Addendum to Final External Peer Review Report

SABINE-NECHES WATERWAY (SNWW) CHANNEL IMPROVEMENT PROJECT FEASIBILITY STUDY

June 16, 2010

**Battelle Memorial Institute's Participation in
Civil Works Review Board for Sabine Naches Waterway, Texas**

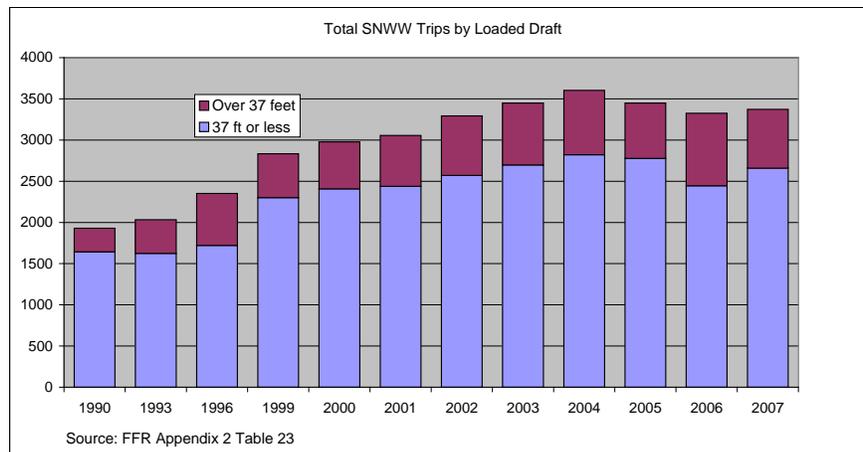
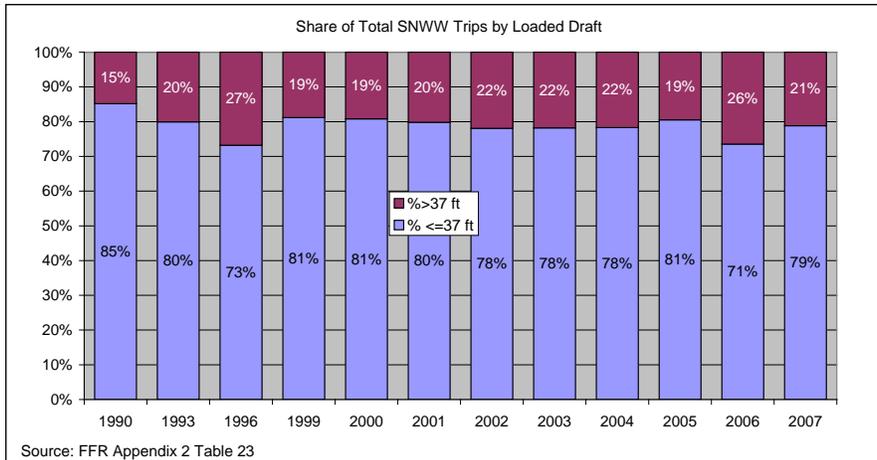
Table 23 does not show an obvious trend toward deeper loaded drafts. The charts below, developed from Table 23, show a modest decline in the number of trips and a stable share of trips with loaded drafts over 37'.

In response to the concern that Table 23 shows a stable share of trips with loaded drafts over 37 feet and appears to undercut justification for the project, the review team needs to recognize that the forecast for the next 50 years cannot be made based on a few years of data. Recent inclusion of 2008 in the figure below shows a slight upturn; however, what is of interest is that the percentage of tonnage shipped in vessels with loaded drafts over 37 feet has exceeded the 1990 levels for 1993-2008 in spite of peaks and valleys. Data from the early 1970s showed less than one percent of total tonnage transported in vessels with loaded drafts over 37 feet; inclusion of this earlier period data is shown in displays prepared in response to IERP.

Figure 22
Sabine-Neches Waterway
Average Tonnage Per Trip for Ocean-Going Vessels

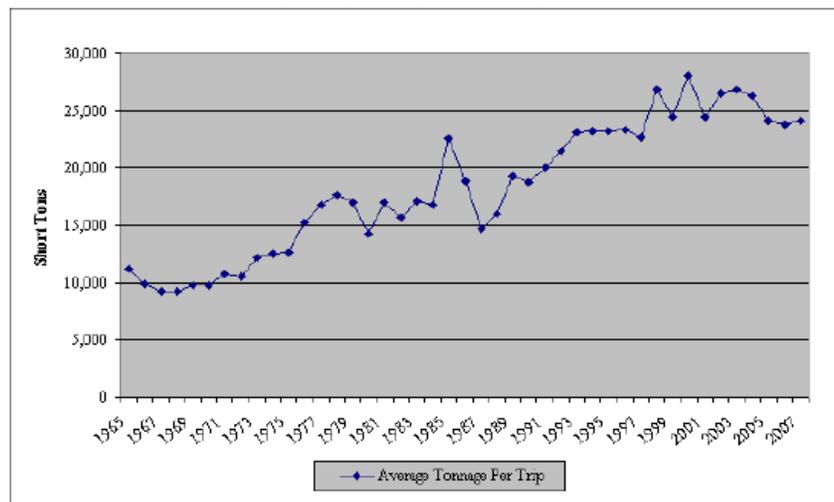
Figure 22, on page 59 p of the Economics Appendix (reproduced below) shows recent modest declines in average tonnage per trip.

These tables appear to undercut the justification for the project, as the trends they show imply falling trade and declining vessel transits. The data in these tables likewise appear to contradict or weaken predictions of cargo growth and rising market share, on which much of the project benefits depend. The report appears to attribute this decline to Hurricane Rita, although no analysis is presented to explain why the downturn persisted so long. The more addition of more recent data to 2010 or at least 2009, would either lessen the IEPR Panel's concerns or further weaken the declining tonnage predictions.

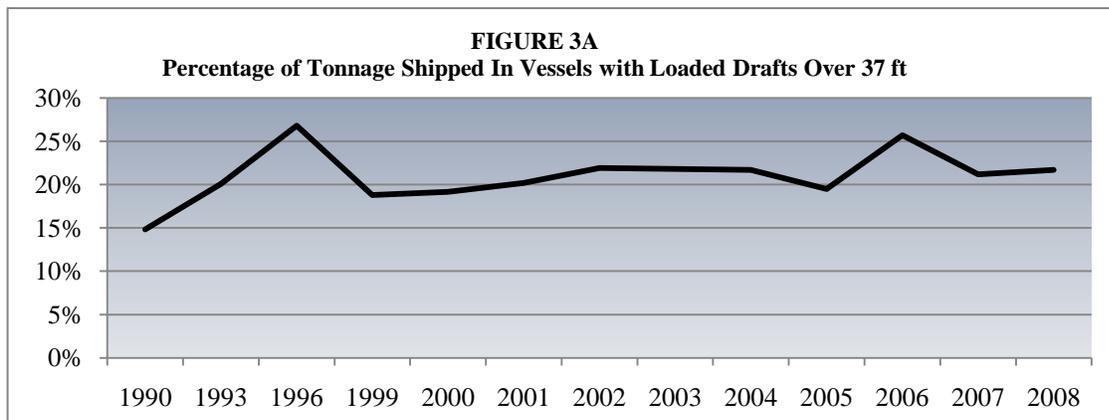
The LNG analysis remains cursory and lacks credibility. The “multi-port analysis” in Appendix 2 (Economic Appendix), Section 2.7 contains barely a full page of text and a chart that shows a declining outlook for LNG imports beyond 2019, which appears to undercut any projections for long-term LNG-related benefits. The discussion in Appendix 2, Section 4.15 (U.S. LNG Forecast) is likewise cursory, and offers no justification for the arbitrary assumption

that SNWW will get 20% of the US market. (see Comment 6). A multi port analysis is a commonly used analytical instrument that allows a more global analysis of trade and traffic. The discussion provided in the current report version falls short of a multiport analysis. USACE guidance or other reports should be consulted as examples of multi-port analysis.

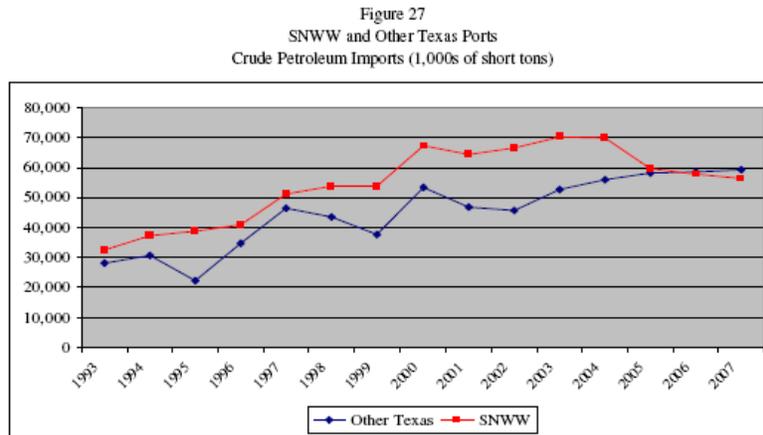
Figure 27 implies a declining share for SNWW. This decline is attributed to Hurricane Rita (EA, p.99), but no attempt was made to include newer data in the analysis. **Prior to the suggested “Rita” effect, the imports had been essentially stable for the previous five years, with little increase (Table 27).**

In overall terms and in spite of a recent decline in the SNWW share of the U.S. total, comparison of overall regional imports using 4-year averages from 1990-2009 shows that SNWW imports grew by 117 percent in comparison to a U.S. increase of 58 percent. During this same period (2004-2009), SNWW's refinery capacity increased from 6 percent to 6.5 percent (Economic Appendix, Table 10). Port Arthur refinery capacity in 2009 is nearly 13 percent higher than in 2004, with additional expansions scheduled. Motiva announced plans for a 325,000 barrel-per-day (BPD) refinery expansion in Port Arthur in December 2007. Additionally, expansion of the Motiva-Port Arthur refinery now taking place and expected to be complete by 2012. Motiva's current capacity of 285,000 BBD will be 610,000 BBD until completion.

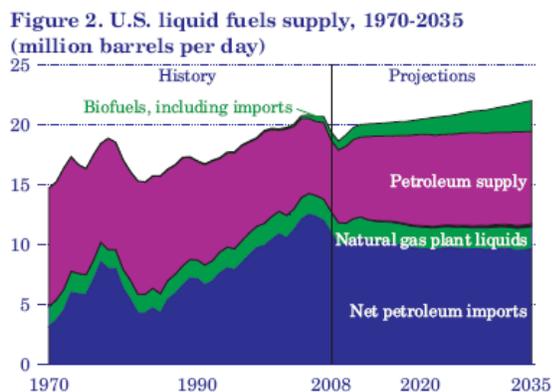
Table 52 shows the latest official U.S. government forecast (AEO 2009), which anticipates a 13.6% drop in crude imports between 2015 and 2030. In Table 55, the report forecasts a 12.3% increase between 2015 and 2303, thus dramatically contradicting the EIA. The AEO 2010, which has just been released, shows declining crude imports between the present and 2035 (below).

Figure 19
U.S. LNG Imports 2006-2030
Trillion of Cubic Feet

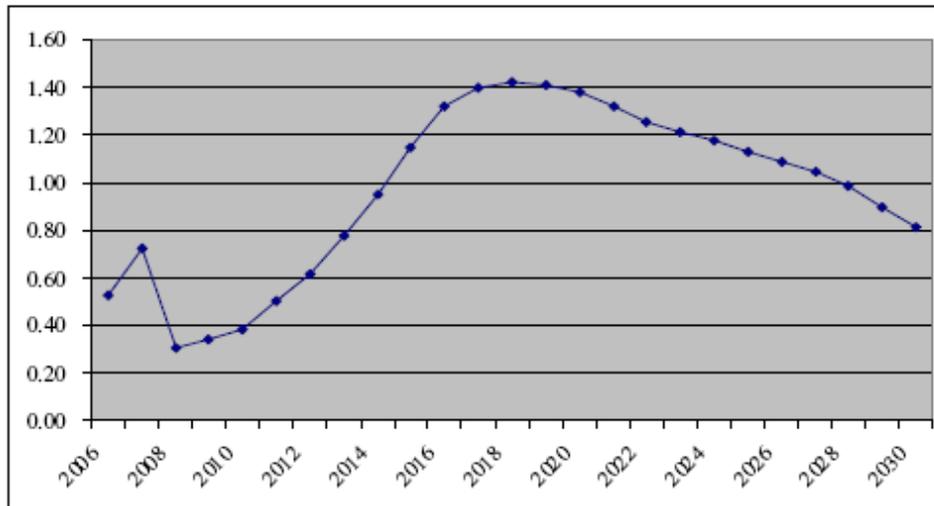
LNG Forecast. As discussed earlier in this series of backcheck responses, the LNG forecast in Appendix 2, Section 4.15 (U.S. LNG Forecast) uses an arbitrary assumption that SNWW will get 20% of the US market. The actual market share forecast in Table 72 goes from 0% in 2015 to 15% in 2019 and 25% in 2020. Table 72 shows the SNWW gaining 3.6 million tons in 2019-2020 while total US imports decline. Table 72 then assumes a fixed SNWW tonnage against a

downward U.S. trend. Table 73 shows higher SNWW volumes than Table 72, without justification. The footnote to Table 73 states that “SNWW 2015–30 volumes are based on application of the EIA 2010–30 growth rates”, but those growth rates are not provided or sourced, and the claim appears to be contradicted by other information in the report. . Figure 19 (below) shows a falling volume between 2018 and 2030. Between 2019 and 2030, the graph suggests a decline of about 43% (from about 1.4 to about 0.8 on the graph), whereas Table 72 shows an SNWW decline of only 4%.

The claimed source, AEO 2009, states (p.78) “In the United States, LNG imports peak at 1.5 trillion cubic feet in 2018 before declining to 0.8 trillion cubic feet in 2030 (Figure 68), despite projected U.S. regasification capacity of 5.2 trillion cubic feet.” In other words, capacity will not generate growth.

Source: AEO2010, p 74

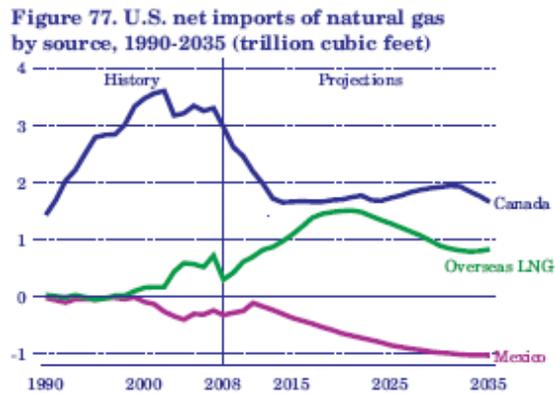
AEO 2010 splits out the overseas LNG imports from Canadian and Mexican sources (below), showing the same declining pattern for waterborne LNG imports as AEO 2009.

Here again the report adopts a forecast that is far more aggressive and favorable to the project than would be suggested by official U.S. government sources. The SNWW forecast is dependent on an unjustified and unsupported assumption of rising market share in a falling market. This analysis in this response simply does not allow the IEPR Panel to concur with the response to our comments. Again, at a minimum, the discrepancy between these forecasts and the Federal Government has to be directly presented, analyzed and defended.
